BZA
Case No. 17127
Exhibit No. 2

Board of Zoning Adjustment
District of Columbia
CASE NO. 17127
EXHIBIT NO. 2

ZONING REGULATION VIOLATIONS ALLEGED IN THE APPEAL

ROOF PLAN

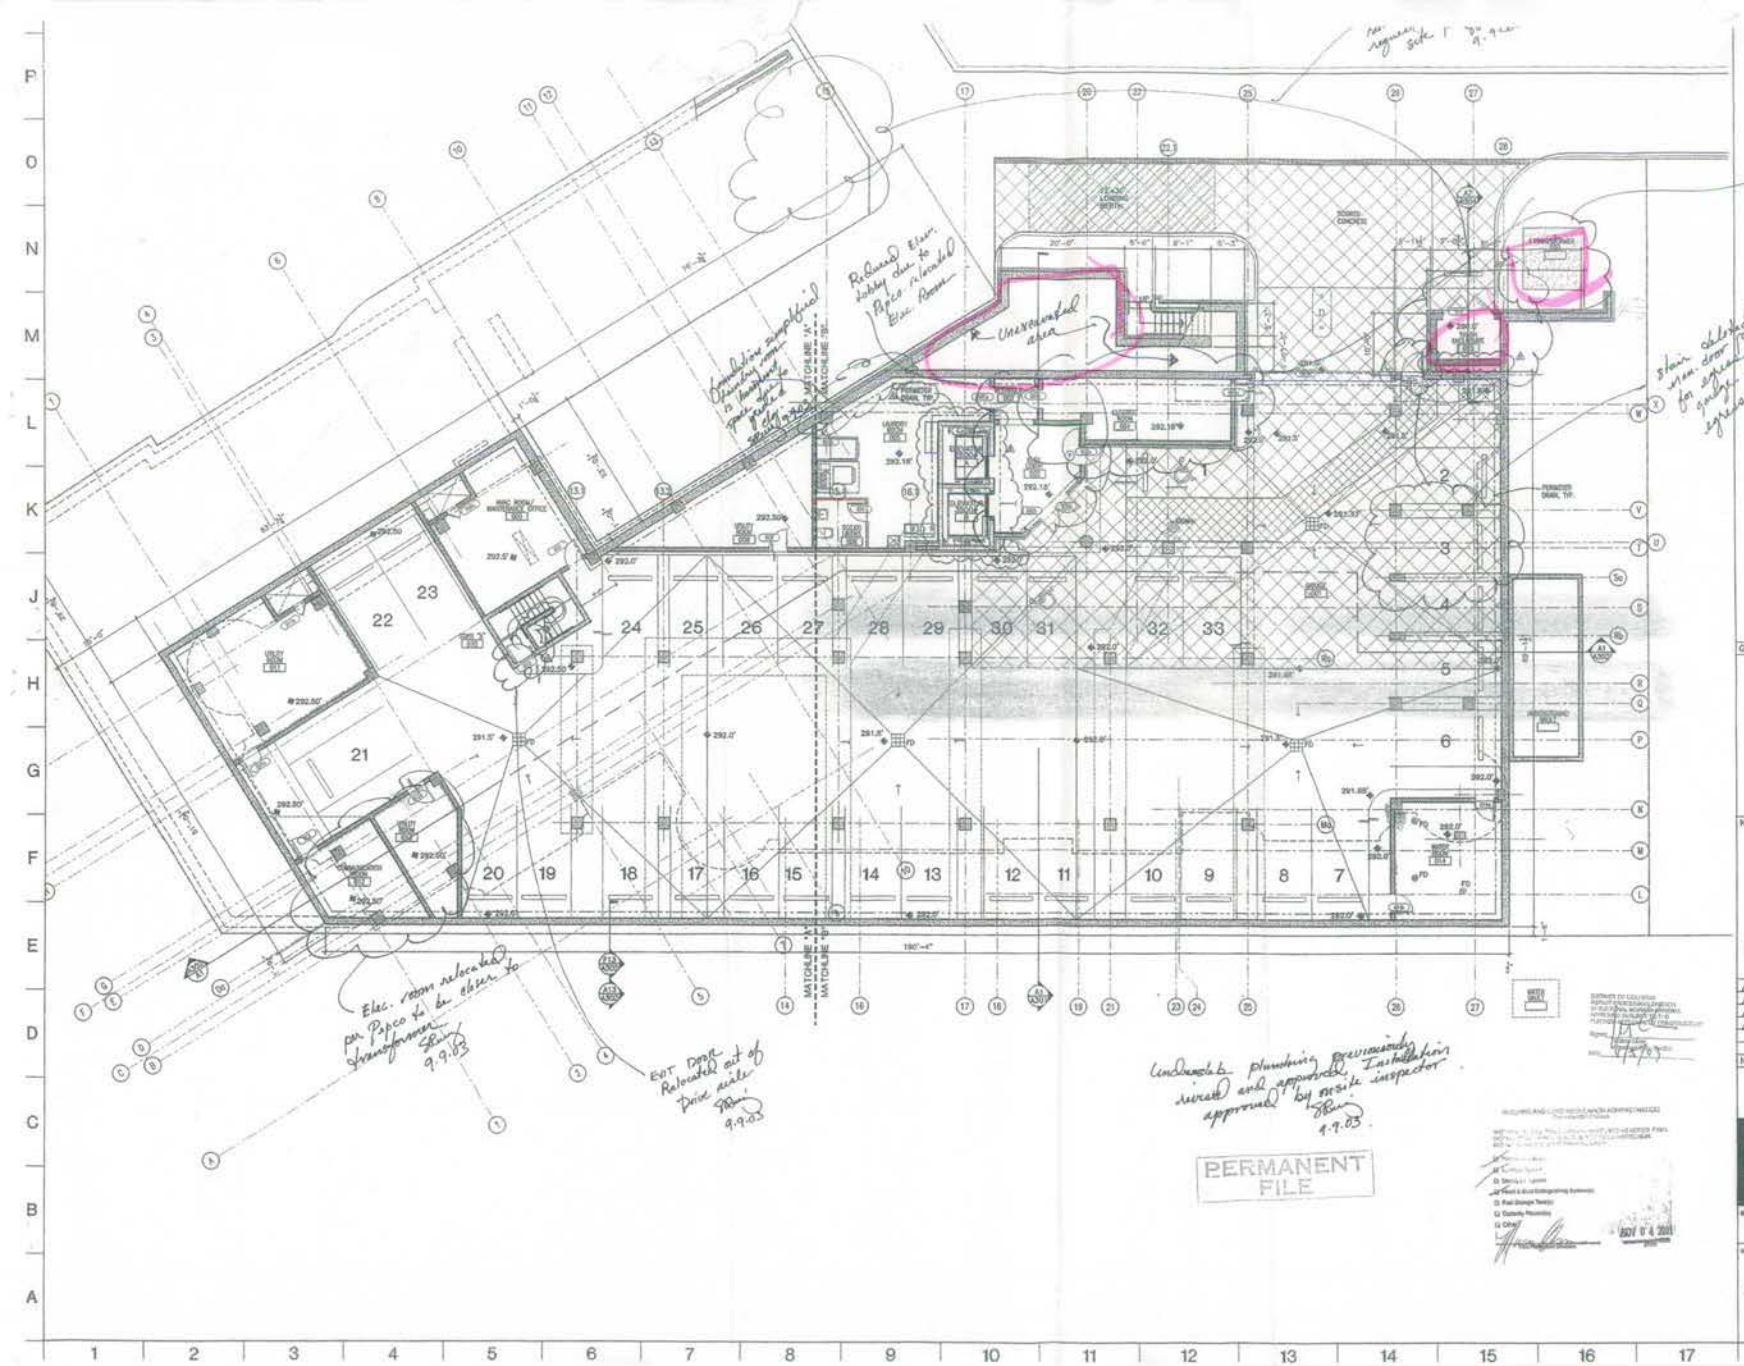
penthouses are taller than 4 feet, they are not exempted from roof penthouse requirements. (Comparison with the previous roof plan (p. 14) shows that changes were made in the roof plan.) The south stair penthouse has no setback. The elevator penthouse is not setback by a distance equal to its total height (§411.5), which is 15 ft. above the *roof on which it sits.* The 15 ft. calculation includes the *sloped roof located on it and over it.* The two penthouses (elevator and stairwell-machine room) are separate and are incompletely surrounded and enclosed in a roof structure. This roof does not comply with requirements of a "curtain wall" (perpendicular, setback, §411.5). It is required by §411.3[4] that roof penthouses on each level be enclosed in a single structure. In addition, the revised roof plan was not submitted to the Office of Planning (§411.10).

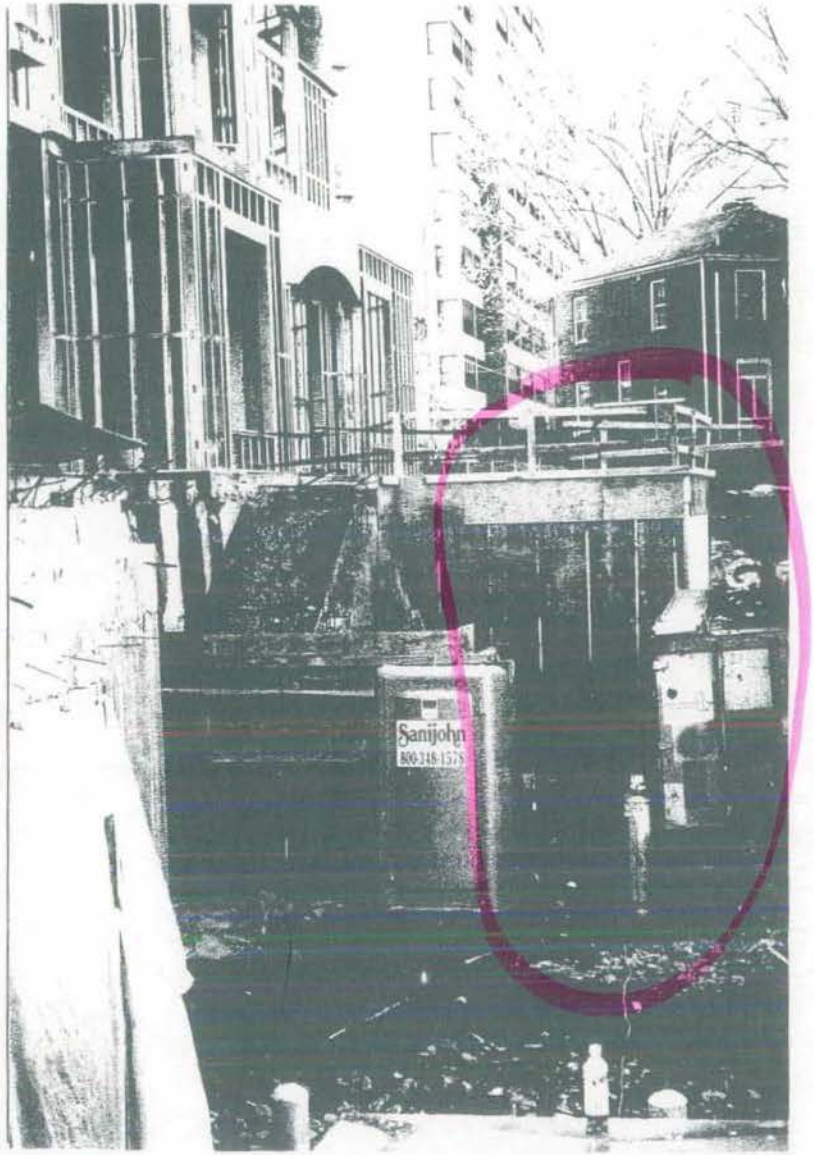
Description of noncompliances (code section):
The building footprint extends into the required rear yard (Wall Test Report dated 5-27-03, p. 5; revised Garage Plan, p. 6) by about 8 to twelve feet both to the left and to the right of the garage entrance (§404.1) and includes a room about 10 feet in height that has been added to the left of the garage entrance in Permit B456618 (photo, p. 7). An open porch about 12 feet high from adjacent grade (photo of rear of building, at grade, p. 7) extends into the required yard on the right (§§404.1, 2502.1). Behind the building, an electric room, about 6 feet high, is also constructed in the rear yard (B456618, Garage Plan, p. 6) (§2503.1). Permit B456618 (11/7/03) Garage Plan includes substantial revisions of the original Garage Plan submitted for Permit B435464, (p. 8).

The additions to the building at the garage level (revised Garage Plan, p. 6) bring the FAR over 3.5 allowed in an R-5-D District or 1.8 in an R-5-B District. In addition, the change in grade adjacent to these additions (lowered compared to original plans, see Grading Plan, p. 11) further increases FAR into noncompliance by increasing the proportion of the garage-level which is basement and decreasing cellar (using the perimeter). The original garage footprint used in the FAR calculation (p. 12) showed the garage perimeter with basement as only 78 feet of an approximate 655 foot perimeter. The new perimeter approximately doubles the feet of basement perimeter and provides additional gross floor space to the Garage-level, increasing FAR well above regulation (§402.4).

The new Garage Plan shows one Loading Berth @30 ft with adjacent loading space (§2101.1). The revised Garage Plan (p. 6, compare with original Garage Plan, p. 7) covers part of the former Service/Delivery Space with an addition to the rear of the building. Between the addition and the alley is labeled "VAN." This would be for the facility van that provides transportation to residents, a service provided at all Sunrise facilities. The required service/delivery is not provided. Furthermore, traffic plans (§2204.7 --(related to use of the alley, and access to the required delivery/loading facilities and the garage) were requested by Ken Laden, formerly of the Department of Public Works. No plans were ever provided (§2101.5).

6
Pepco relocated transformer and elec. room per Verde/Isley plan sheet and approved.
9.9.03
Revised Elec. lobby due to Pepco relocated Elec. Room
Unenclosed area
Condition simplified. Opening now to be at existing grade & storefront
Stair added at new door for egress from garage & direct access to upper floor & grade above.

9.9.03
Elec. room relocated per Pepco to be closer to transformer
9.9.03
EXT Door Relocated out of Drive aisle
9.9.03
Underslab plumbing previously inspected and approved. Installation approved by onsite inspector

Addition Extending into the Rear Yard

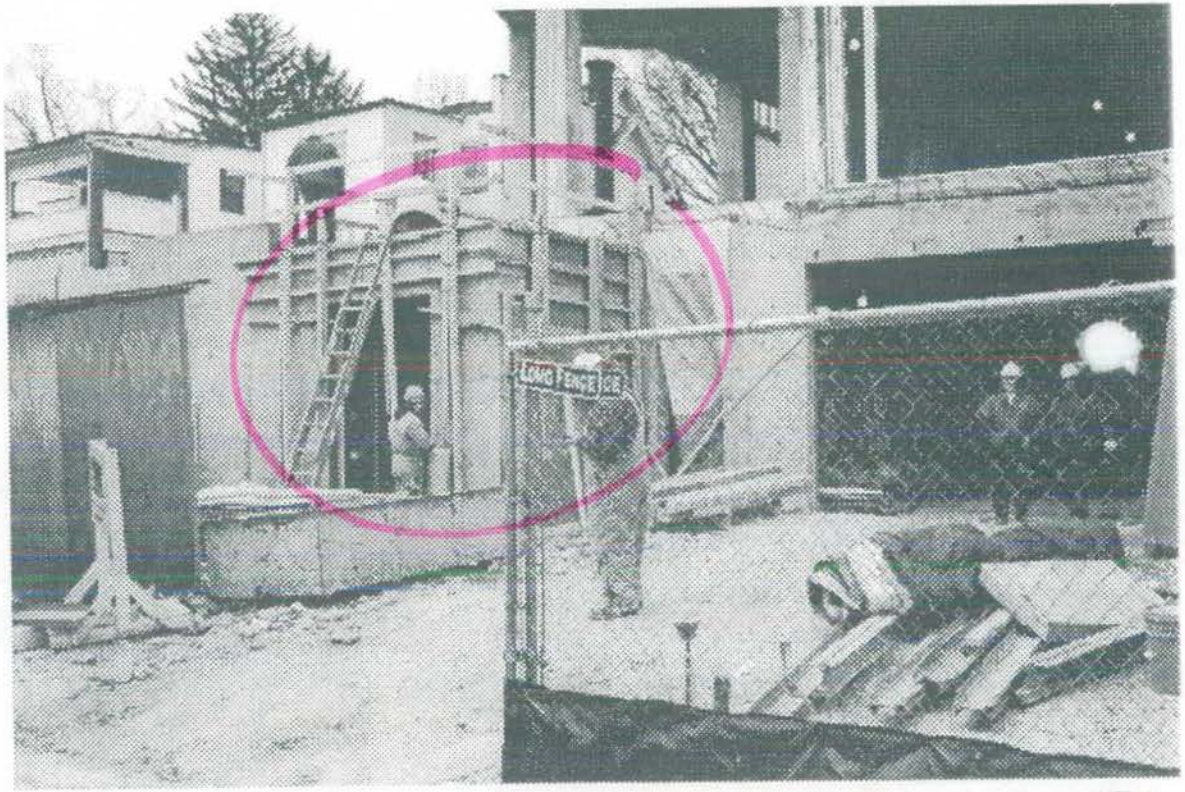
Rear Open Porch
